SERVICE BULLETIN

B-021A

SAFETY RECALL CODE 0814 - FUEL TANK RETENTION SYSTEM

Figure 1. Original Fuel Tank Mounting Arrangement

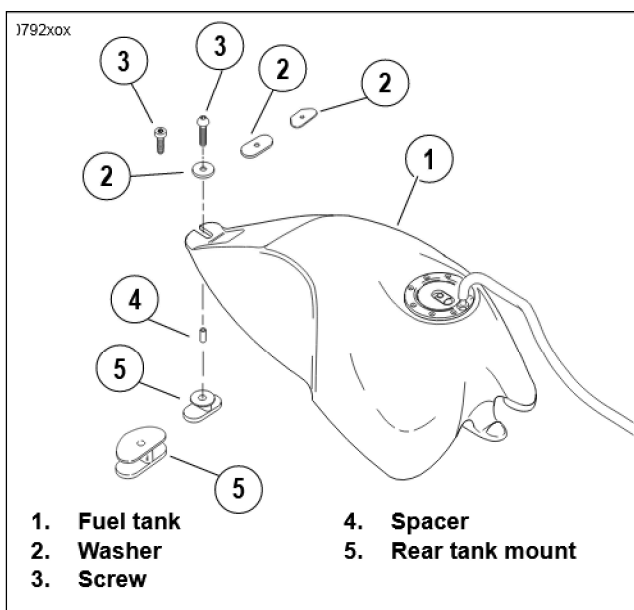
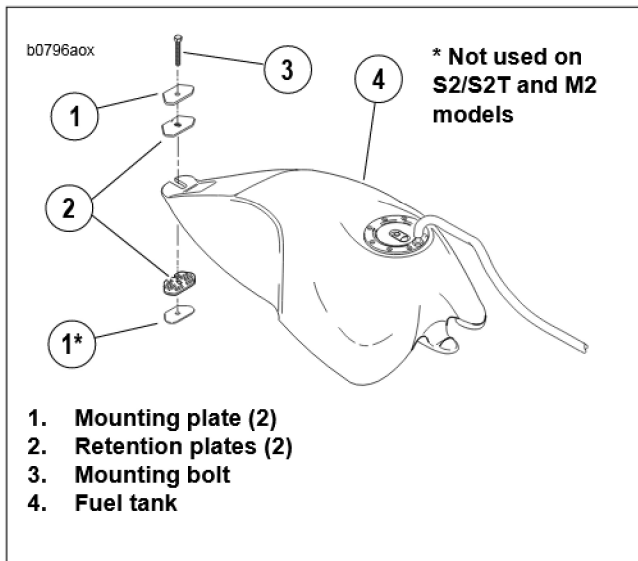
See Figure 1. Vehicles being serviced will have varying combinations of tank mounting parts. Once removed, Items 2, 3, 4 and 5 are to be discarded.

- See Figure 1. Remove and discard fuel tank mounting screw (3) and washer (2).
- While securely holding fuel tank, carefully slide rear tank mount (5), with spacer (4), to the rear of the vehicle and away from the tank. Discard mount and spacer.

- See Figures 4 and 5. Place the remaining retention plate and mounting plate in position on top of the fuel tank rear mounting projections. Make sure shorter straight side of both retention plate and mounting plate face to rear of vehicle.
- See Figure 5. Install new mounting bolt (4) and tighten to 18-23 ft-lbs. (24.4-31.2 Nm).
- Wait five minutes and tighten bolt again to 18-23 ft-lbs (24.4-31.2 Nm).

Figure 2. Retention Plate with Decal

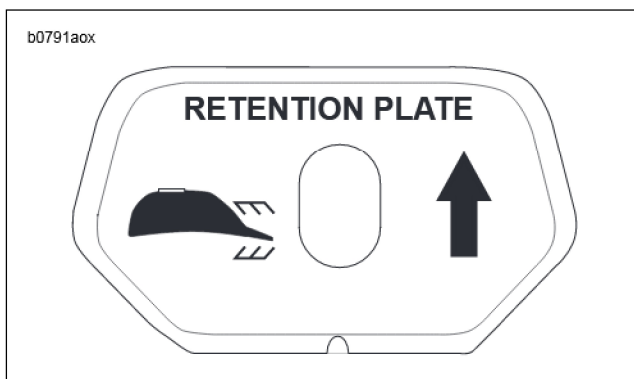
See Figure 2. The retention plates have decals on them showing the position and direction that they are to be mounted. Also, they have a V-shaped notch on the shorter straight side which must face to the rear of the vehicle.

Figure 3. Bottom Plate

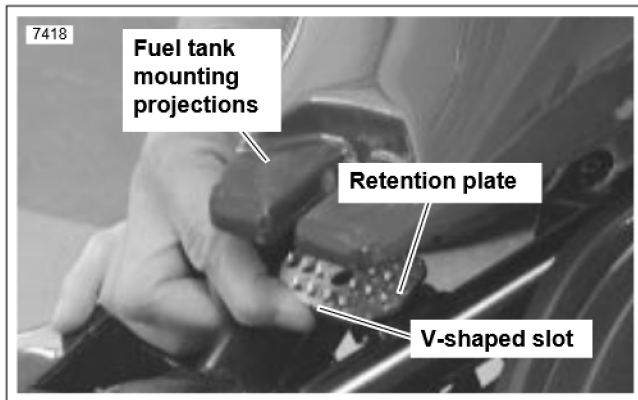
- S1/S1W/S3/S3T Models:** See Figure 3. Carefully raise the back of the fuel tank and place a mounting plate and a retention plate in position on the frame. Make sure shorter straight side of both retention plate and mounting plate face to rear of vehicle.
- M2/S2/S2T Models:** See Figure 3. Carefully raise the back of the fuel tank and place a retention plate in position on the frame. Make sure shorter straight side of retention plate faces to rear of vehicle.
- Carefully place the fuel tank onto the lower retention plate.
